Docket Item # 2 & 3  
BAR CASE # 2011-0282  
2012-0023

BAR Meeting  
March 28, 2012

**ISSUE:** Request for construction of 39 townhouses and 4 triplexes in Phase III of the James Bland Redevelopment Project, *and*  
Request for construction of 27 townhouses, 4 triplexes and a park in Phase V of the James Bland Redevelopment Project

**LOCATION:** 918 North Columbus Street (Phase III) *and*  
998 North Alfred Street (Phase V)

Figure 18. Typical roof plan.

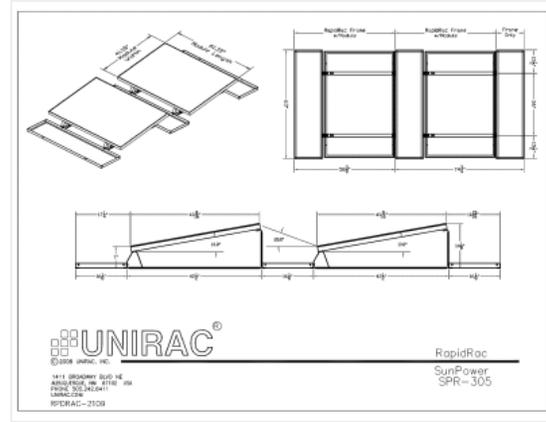
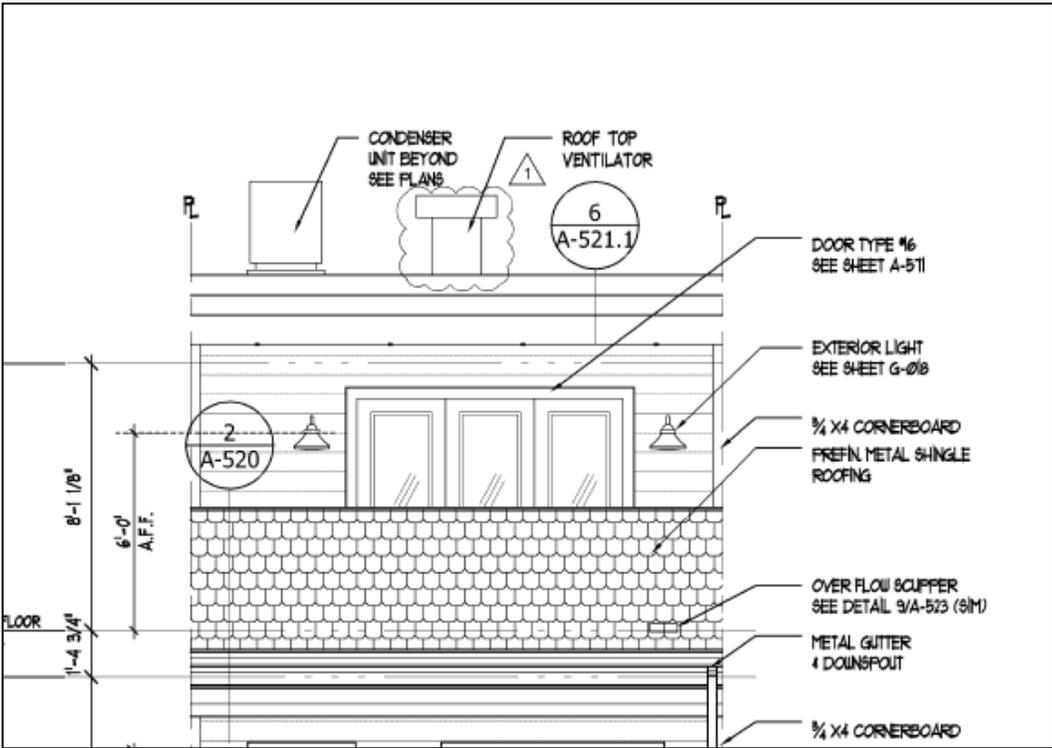
The majority of the rooftop HVAC units remain visible from the public way and often from multiple vantage points. Staff is concerned that the roof plan does not actually match the site line elevation provided in the submission. The Board has requested that all of the manufacturer’s brightly colored stickers and labels be removed from these units.

The applicant has recently become aware of building code requirement for gravity roof ventilation. The applicant has suggested building a chimney-like feature and has constructed a mock-up at the corner of Montgomery and North Alfred streets. These elements will be clearly visible but Staff notes that rooftop appurtenances such as chimneys and flues have historic precedence. Staff finds that it will add a more organic quality to the rooflines, typical of the historic district, and more importantly, these elements will lessen the visual impact of the rooftop HVAC units. However, Staff cannot support the cladding of these features in white EPDM and recommends that the appearance of a more material be used, such as a HardiPanel, simulated stucco finish painted a neutral color. Staff also recommends that more detail be added to the metal cap to more closely approximate the corbeled brick termination of historic masonry chimneys and flues. Staff supports these additional features, once revised.

1. That the Board waive the screening requirements for the rooftop HVAC units but that the applicant further study how to minimize the visible impact of the rooftop HVAC units. In addition, the applicant must submit a mechanical equipment and rooftop ventilation roof plan for each phase of the project for final approval by Staff, prior to issuance of building permits, and work with Staff in the field to locate the HVAC units, so that they are not visible or are placed in the most subtle location feasible. All stickers, markings and labels not required by the manufacturer to remain must be removed from all rooftop equipment.

2. That the applicant revise the rooftop ventilator “chimneys” to have a simulated stucco finish and be painted a neutral color. The applicant may not use white EPDM to clad this feature. The metal chimney termination cap details must be approved by Staff in the field.
